Our Ref: 3356A/BC/AS/20140815

**Re: Response to Submissions – Section 75W Minor Modification to Project Approval  
07\_0066 – Marine Fuel Storage/Distribution Facility, Kooragang Island - Change to  
Storage Tank Design**

EMERGENCY FIRE SERVICES  
SITE LAYOUT

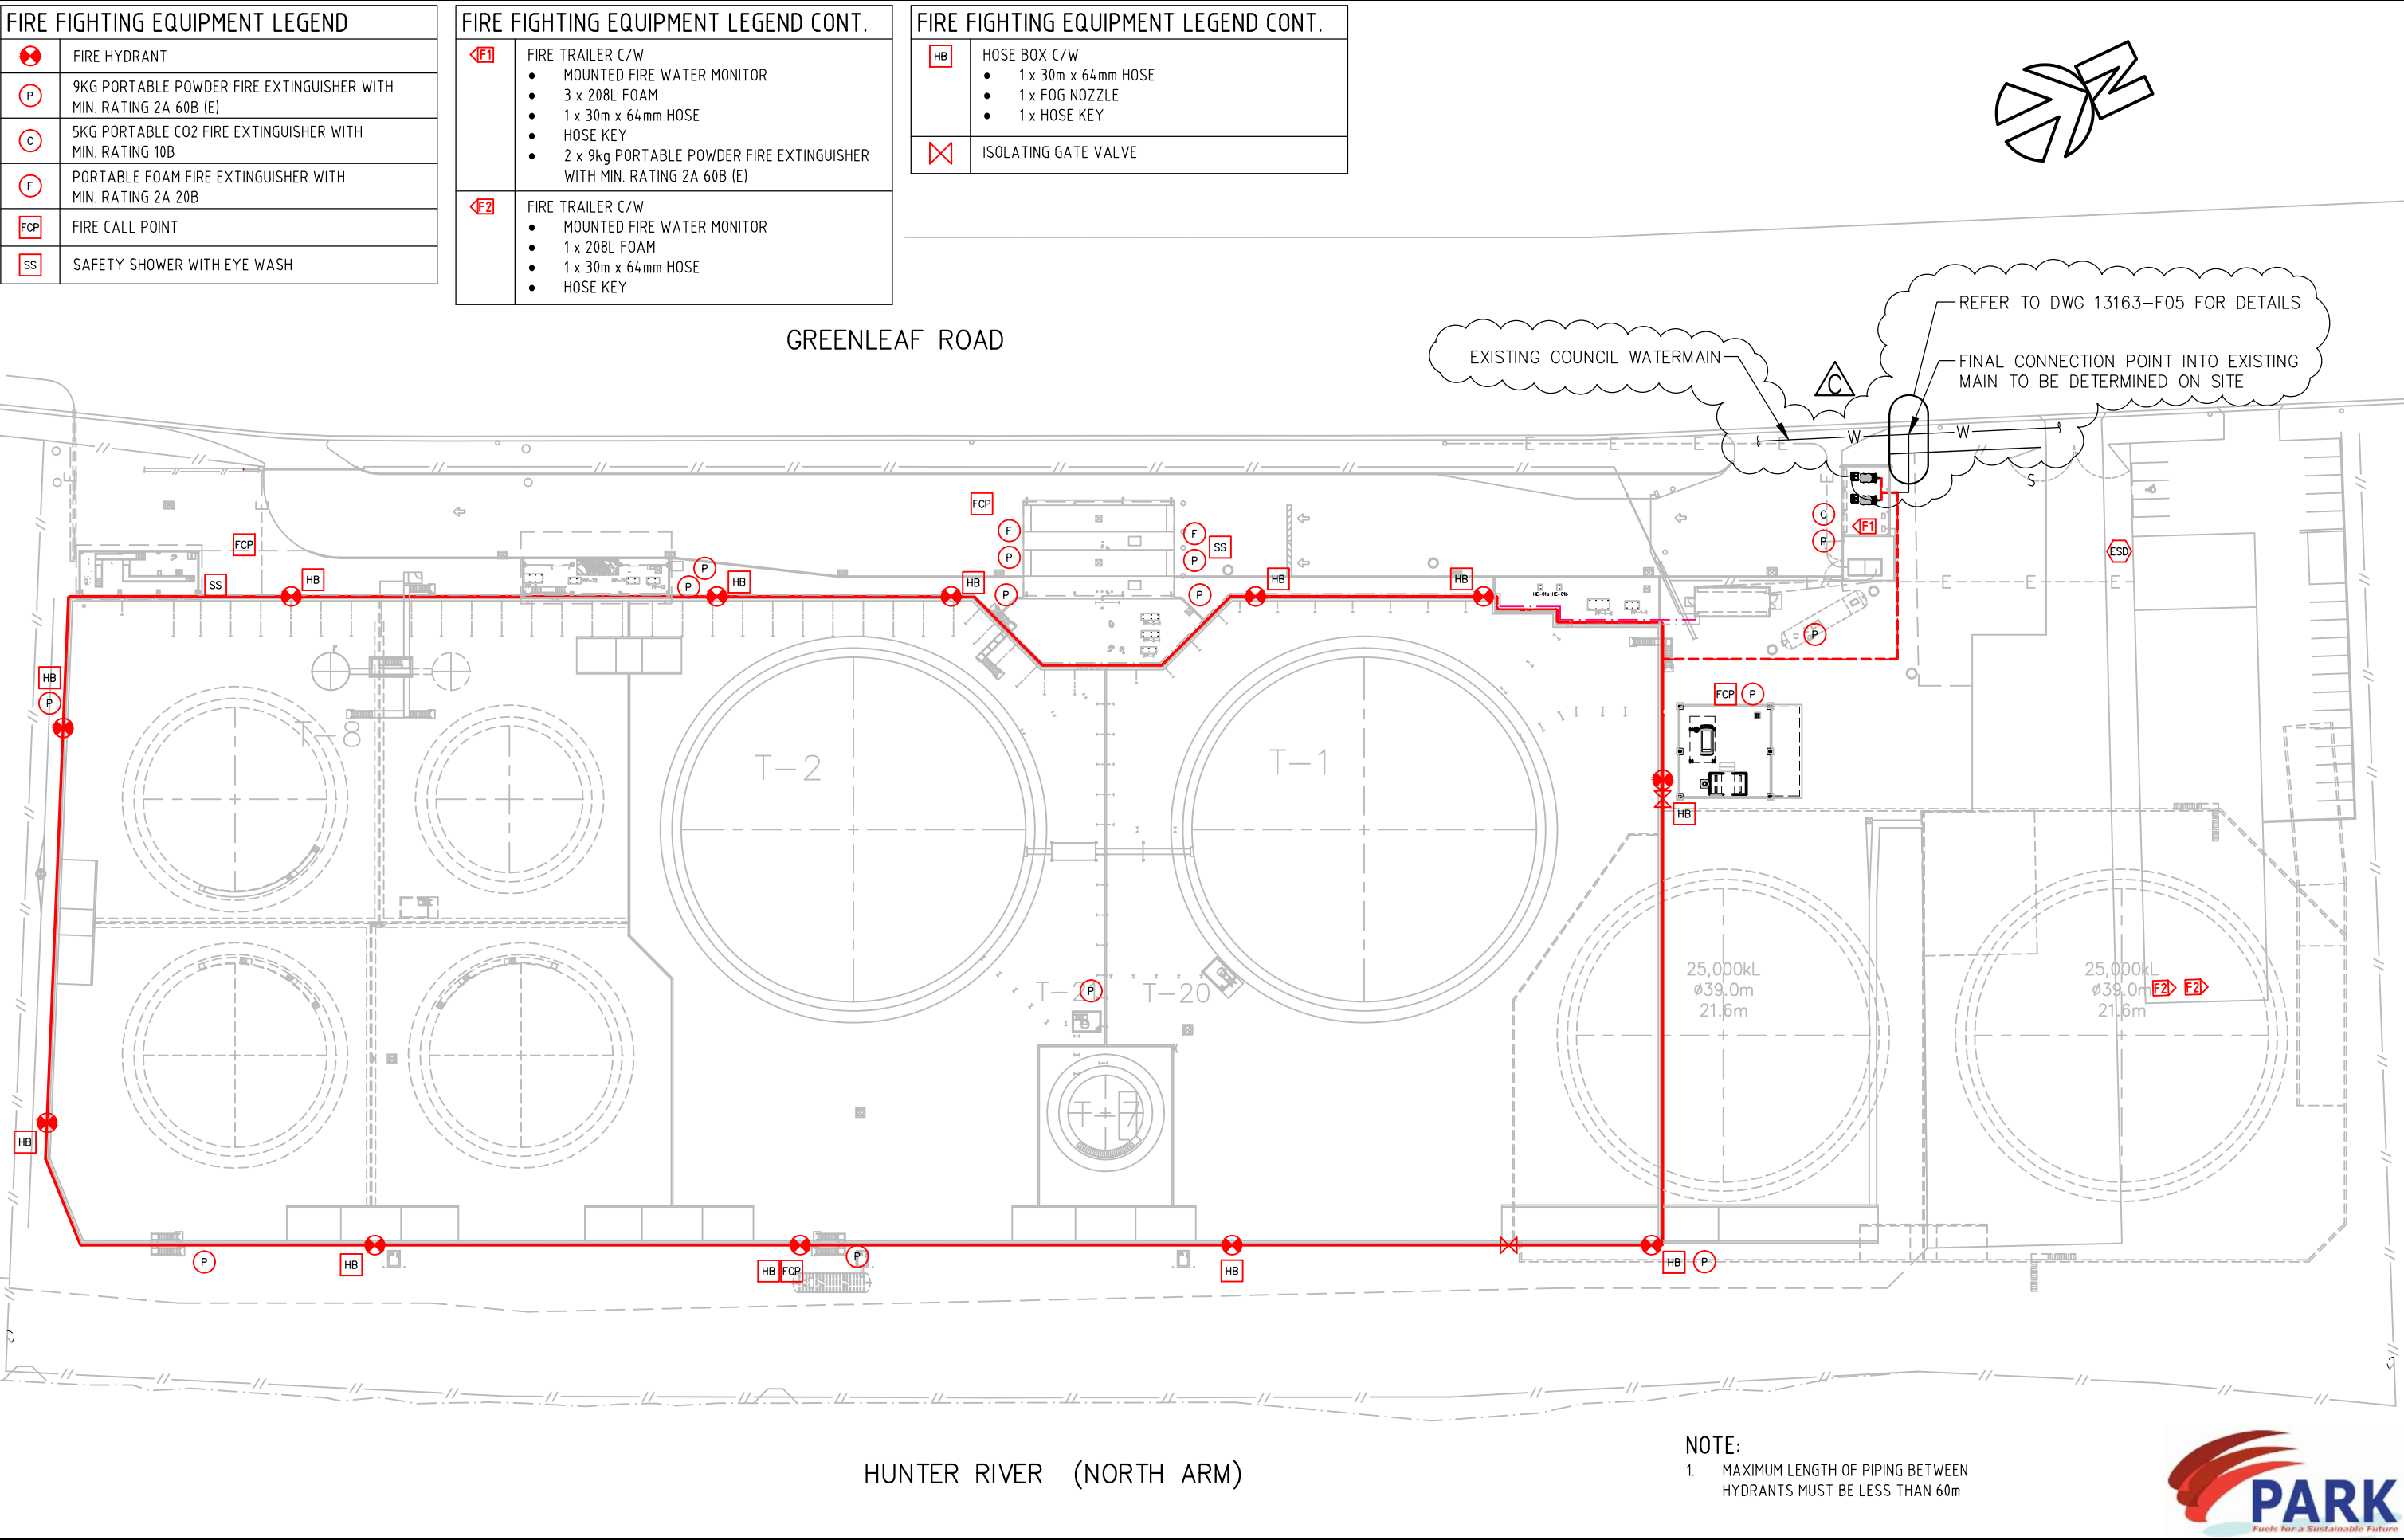
- The Fire Safety Study (FSS) addenda imply that it is now proposed that only 3 mobile firewater/foam solution application monitors are kept on site, mainly for the protection of the road tankers loading gantry. This indicates that the foam deluge system recommended in the FSS for the loading bays has been ruled out. The volume of foam concentrate stock to be kept on site is not provided. [DP&E] recommend that the proponent seeks the opinion of NSW fire service in writing with respect to whether any foam stocks should be kept on site. Regardless of the requirements of AS 1940, it is good industry practice that semi-fixed foam delivery systems are provided for fixed roof C1 bulk liquid storage tanks, and or that sufficient foam concentrate stocks are kept onsite in order to mount a single attack on the largest full surface tank top fire, or a large spill within a tank bund. We seek a response from the proponent regarding this point.

The recommendations for the loading bays contained in the original Fire Safety Study (Clause 8.4), as approved by the NSW Fire Brigade, were to install either a deluge system or, alternatively, mobile fire water monitors. It is noted that either option is in excess of AS1940 requirements for combustible liquids. The 2009 study action plan defined the action for this item as the implementation of three mobile fire water monitors.

The mobile fire monitors will be retained as per the FSS action plans and FSS addenda. A copy of the Fire Fighting Site Layout Plan is enclosed as Attachment 2. Copies of the Fire Safety Study, Hazard Study and HAZOP reports prepared for the originally approved Project are available and can be forwarded to DP&E if required.
